July 27, 2024

**RE: July 30, 2024, Special City Council meeting, Item 2
Community Development, Public Hearing for Stage I Preliminary Design Review
Case No. PDR-002684-2023 for the Development of a New 40-unit, 5-story Multi-Family
Development with 73 parking spaces and Public Open Space Area on a
14,988 square-foot (SF) lot located at 126-128 South Kenwood Street**

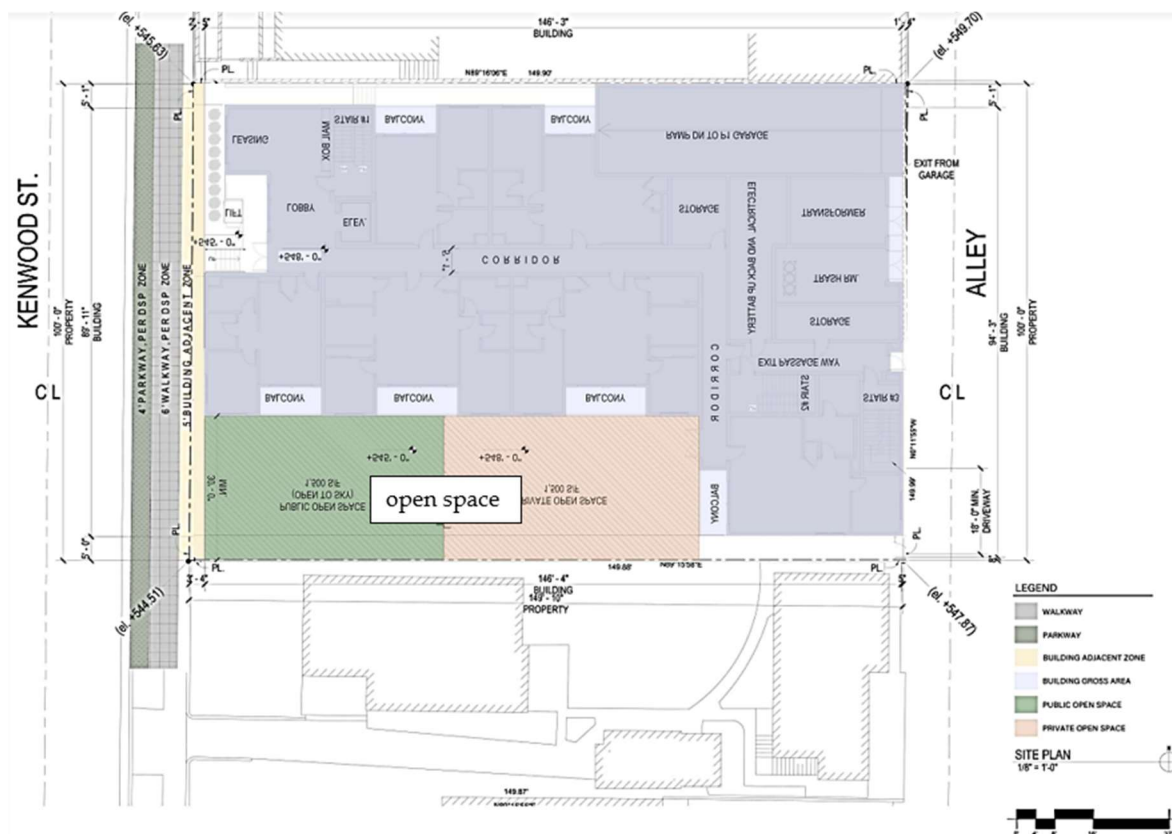
1. That the applicant redesign the site plan so that the ground floor open space, which includes the publicly accessible courtyard, be located adjacent to the historic house at 132 South Kenwood Street (page 12).

Presumably, what staff means is that the proposed project design would be “flipped” on its axis, and the proposed public and private open space would abut the Cole Property at 132 S. Kenwood. See Figure 3 below.

That proposed condition would certainly improve the proposed project, and while it would lessen the expected CEQA historical resource impacts to a less than significant level, it would be a positive step toward reducing the project’s effects on the Reverend Clifford A. Cole Property. Other recommended conditions would be to step the proposed building’s façade back, floor-by-floor, to alter the proposed materials as well as its design to be more compatible and less differentiated from the simple, small-scale historic resource, to reduce the number of balconies looking into the historic resource’s yard and to require the use of camphor trees as the proposed project street trees. The Report to the Special City Council also addresses the large amount of stucco proposed on the exterior.

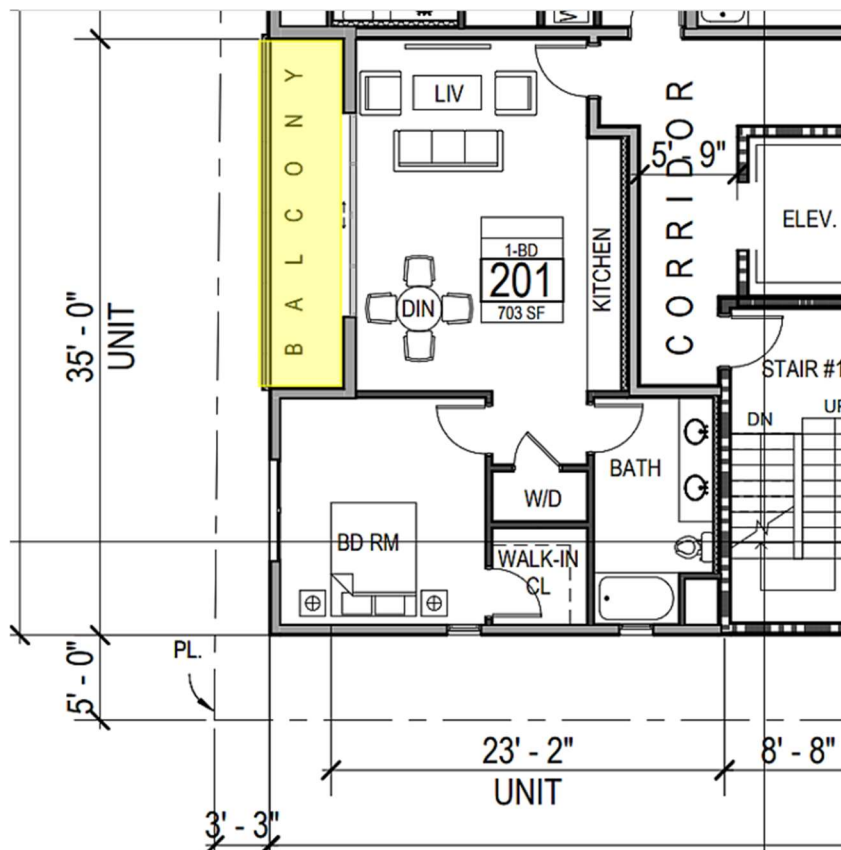
What this analysis reveals, particularly considering Figures 4 and 5, is that the canopies that are proposed to support proposed project compliance with requirements in the DSP do not technically qualify as canopies. They are instead *“area[s] being used as a balcony for an upper floor occupancy.”* The red and green arrows in Figure 5 and the highlighting in Figure 6 point to examples where the canopies could not be considered the required design features when they would serve as balcony decks and roofs. Moreover, the proposed “canopies” would be merely slight projections from the main, nearly flat facades, painted in a contrasting color. As such, the proposed design does not comply with the DSP requirements, particularly by relying on 1-2-foot-deep, minimal façade projections which are not allowable as decks and roofs but are being considered improperly to be canopies.

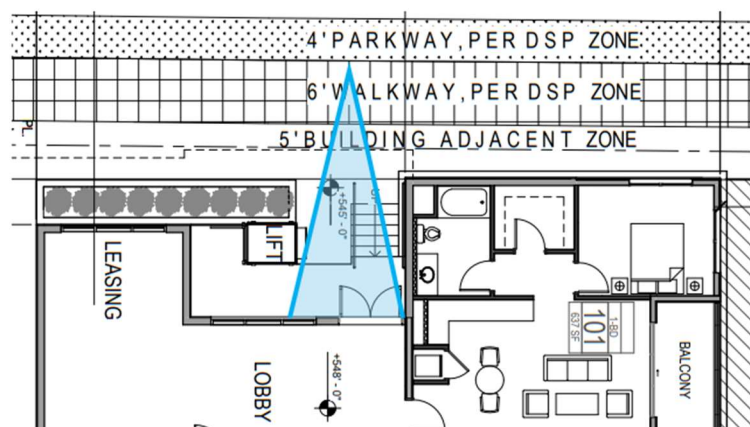
Nothing in the Phase 1 submittal demonstrates a demonstrably or especially pedestrian-friendly project. The same proposed project description states that "The massing and scale of the building are complimented by the canopies separating ground floor from upper floors." However, neither the massing⁸ nor the scale⁹ would be in any way enhanced or visually reduced by the proposed shallow, insignificant and nearly imperceptible canopy overhangs shown on sheet A1-10 (see also separate discussion of canopies on pages 6-8).
